# Joint Regional Planning Panel

<b>JRPP Number:</b>	2014SYE022
<b>DA Number:</b>	DA-2014/255
<b>Local Government Area:</b>	ROCKDALE
<b>Proposed Development:</b>	Rockdale City Aquatic Centre - Demolition of existing pools and associated facilities and construction of a new outdoor 50 metre pool and an indoor aquatic and leisure centre including parking for 150 vehicles, site works, landscaping and signage
<b>Street Address:</b>	98C Preddy's Road, BEXLEY NSW 2207
<b>Applicant/Owner:</b>	Rockdale City Council
<b>Number of Submissions:</b>	Sixty seven (67)
<b>Recommendation:</b>	Conditional approval
<b>Report by:</b>	Kerry Gordon – Consultant Town Planner

## Precis

Front elevation – fronting Preddys Road

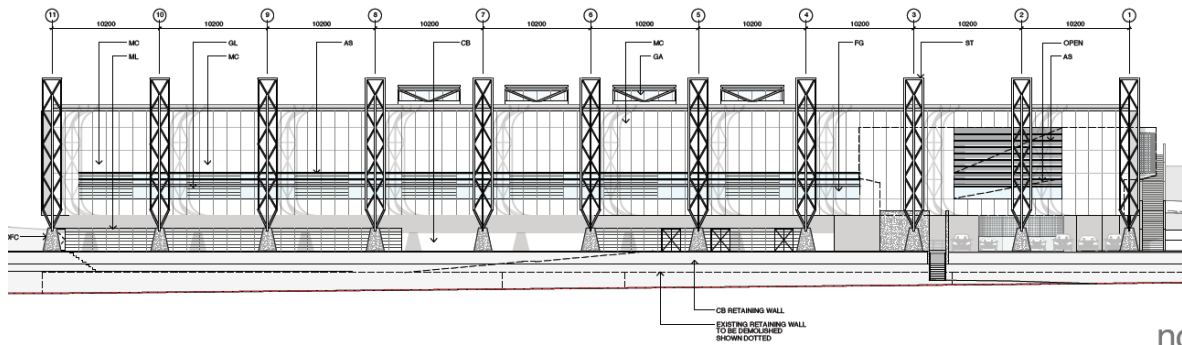
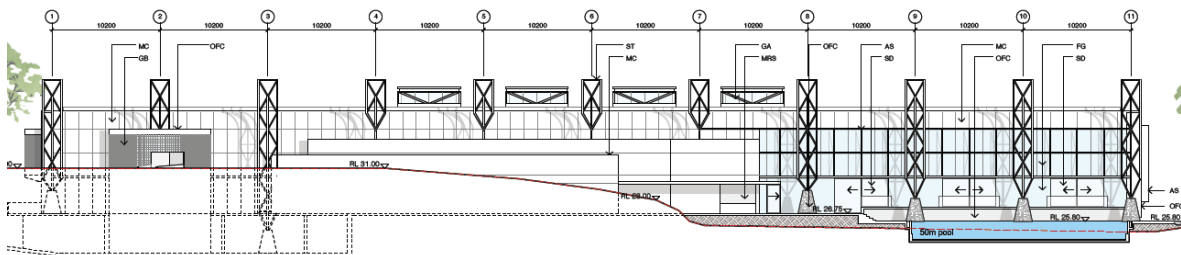
*In such a natural suburban context, the building appears closed and functionalist. Rather than provide shaded edges and overhangs for comfortable pedestrian movement, the building is about its internal functions only ie. Providing protection to its internal space but little to the outside. This makes the building appear heavy and not comfortable in its context.*

*Generally the scale of the proposal is acceptable. However the use of strict orthogonal planning, taut box profile and external trusses does not create comfortable external spaces at a lesser scale around its edges. The layout also requires cutting into to the sandstone escarpment which compromises the existing context (as discussed above). As such, the proposal is denied a chief way to mediate with its surroundings and create amendable spatial relationships.*

*While the architects have explained their rationale for using external trusses, the current design appears clumsy and heavy handed against its natural suburban context. See notes above. This is exacerbated by the trusses disappearing into the top of the amenities block which is again, awkwardly placed. The building does not provide comfortable protected edges and appears not to sit comfortably on its site.*

The above comments were provided in relation to the initial design of the proposal and amendments have been made to the design of the proposal which, in part, address the panel's concerns. Further, it has been determined that the escarpment referred to in the panel's comments, whilst attractive in parts, is the result of previous quarrying on the site

The northern façade of the building and the internal spaces at the first floor level have been redesigned to provide for more opportunities to view the adjoining Parklands from within the proposed building.

It is noted that the main entry has an elongated eave overhang which provides weather protection and it is not agreed that the entry pathway should be provided with weather protection.

It is not agreed that the building needs to be redesigned to provide overhangs around the building for comfortable pedestrian movement. The pathway to the north is overhung by the design and as such afford protection to pedestrians. The building, by virtue of its orientation, provides a shaded area for users of the site and this includes the terrace to the kiosk. Other shaded areas will be available to the users of the outdoor pool by virtue of the shade structures and tree planting.

It is considered that the amended design achieves an appropriate balance between form and design, with the materials used being muted and reflective of the water based use of the building and with the curved element of the roof trusses and building shape softening what could otherwise be a large and harsh building.
